# Recall Bulletin

## F/CMVSS NONCOMPLIANCE RECALL

**SUBJECT:** Instrument Panel Storage Bin Door Compliance – Add Reinforcement Bracket

**MODELS:** 2006-2008 Chevrolet HHR

2200528

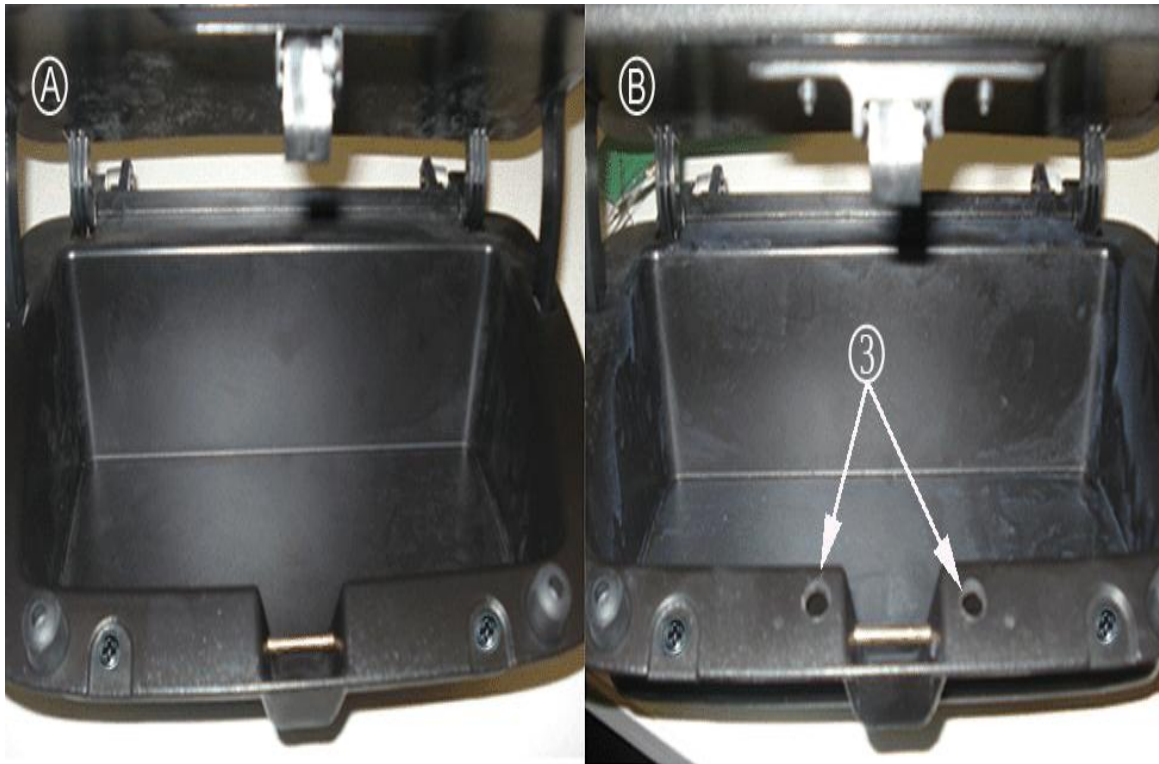
1. Locate and open the instrument panel storage bin (1).
2. Locate the instrument panel storage bin latch (2).

2219118

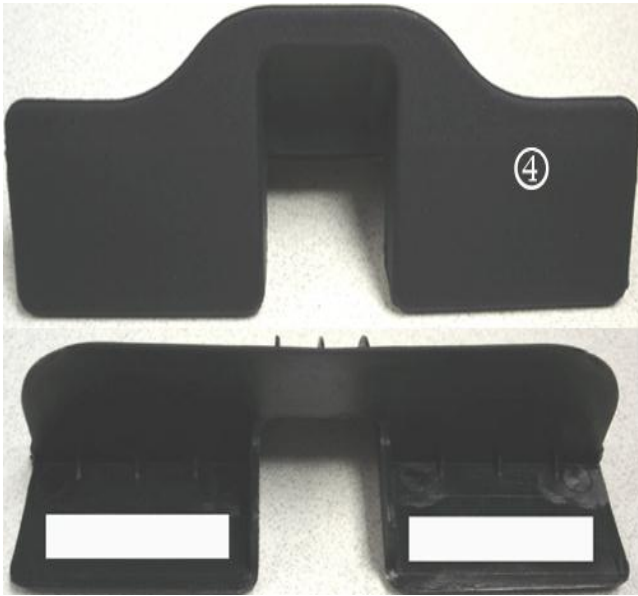
3. Determine if the storage bin is a first (A) or second (B) design storage bin. The second design storage bin (B) includes latch pin holes (3) on the left and right side of the latch.
  - If the vehicle is equipped with a first design storage bin (A), installing a reinforcement latch plate bracket IS required. Proceed to Step 4.
  - If the vehicle is equipped with a second design storage bin (B), installing a reinforcement latch plate bracket is NOT required. No further action is required.
